**Society for Water, Power & Natural resources  
conservation Awareness and Monitoring**

Sub: Amendment to the regulations – 4/2017 - Certain Suggestions – Submitted - Reg.

Ref: 1. Public Notice Dt. 13.2.2020 by the Hon'ble APERC

## EXHIBIT-1

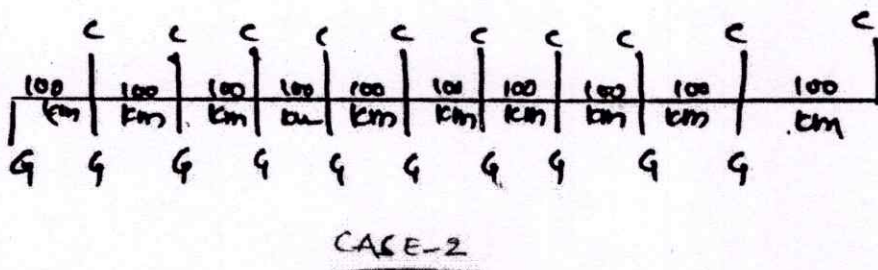
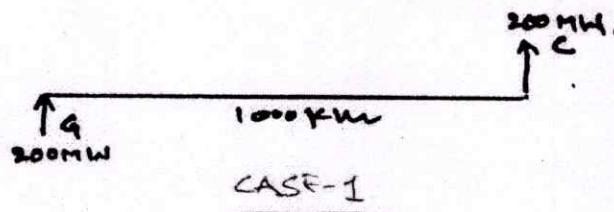
- b. Please see Exhibit-1. For ex, the transmission loss alone is 31.59% for transmitting 200MW power through 220kV line for 1000km. The loss can be reduced to a level of 3.159% if 2000MW is pumped in and drawn at 10 locations @200MW. This exhibits the fact and necessity of generation & utilization of electricity at the same node/place. Further the capital cost of network for transmission of each kWh will also gets reduced.

- c. Therefore, location of generation, its transmission and utilization is playing huge impact on overall cost of service to the consumer and therefore shall be compensated by the generators for deviations from their own schedules.
